## ***Proposed modifications to section 9.3 shown below***

### **9.3 The stratified event scheduler**

<NEW FIG 9.1> (There are two choices proposed - selection to be made in the SV-EC)

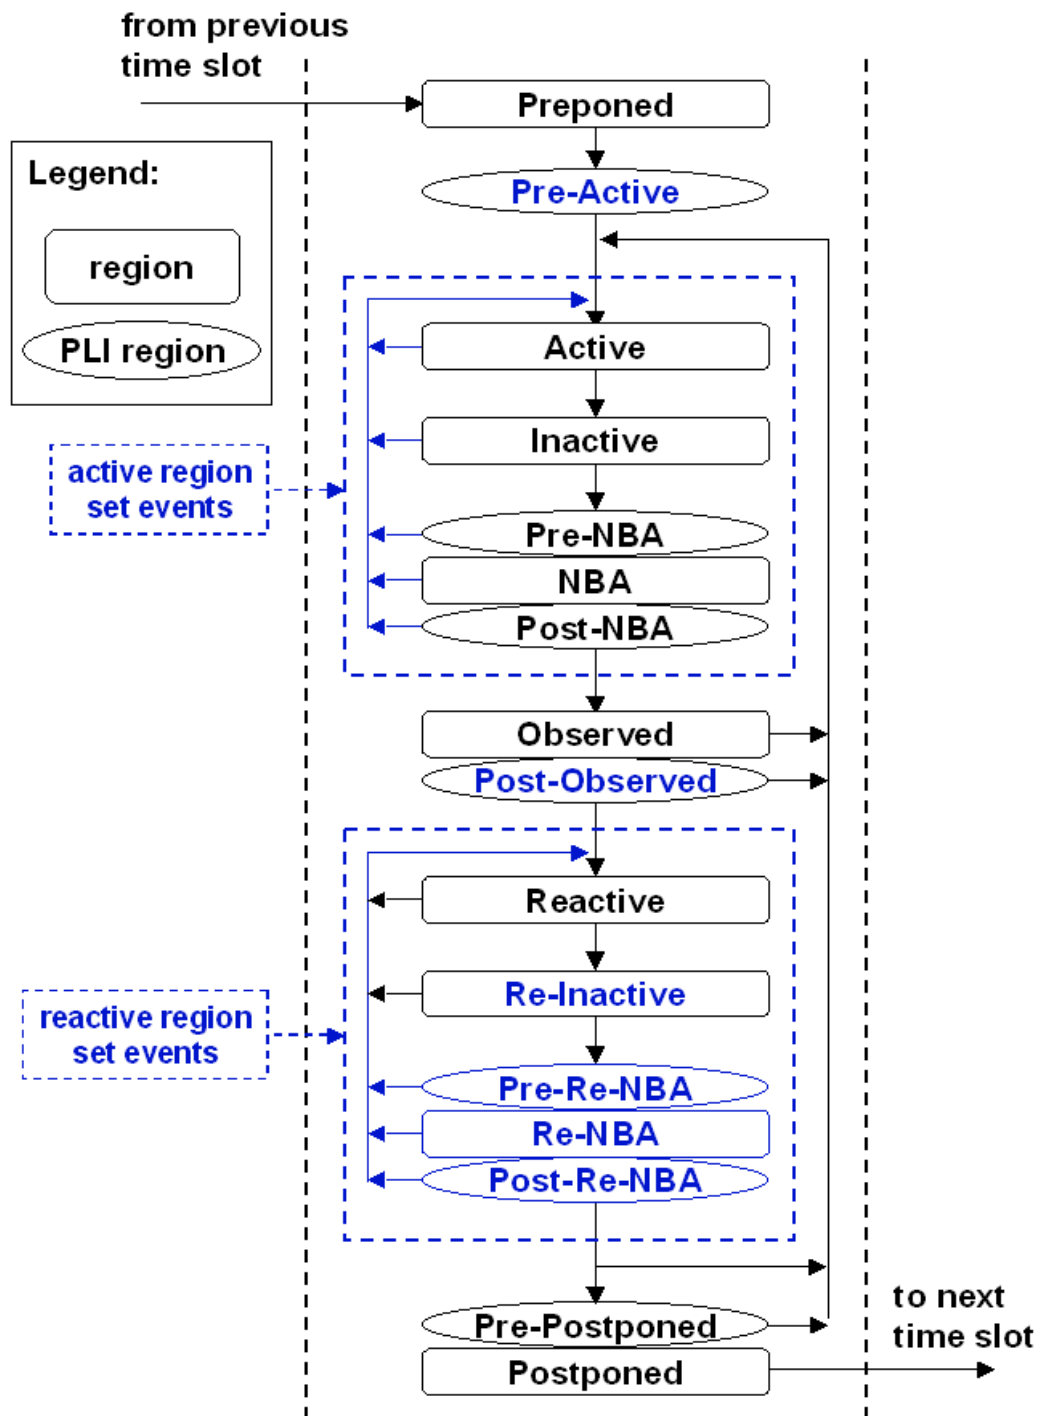
The simulation regions of a time slot are the Active, Inactive, NBA, Observed, Reactive, Re-Inactive, Re-NBA and Postponed regions. The flow of execution of the event regions is specified in Figure 9-1.

The PLI regions of a time slot are the Preponed, Pre-Active, Pre-NBA, Post-NBA, Post-Observed, Pre-Re-NBA, Post-Re-NBA and Pre-Postponed regions. The flow of execution of the PLI regions is specified in Figure 9-1.
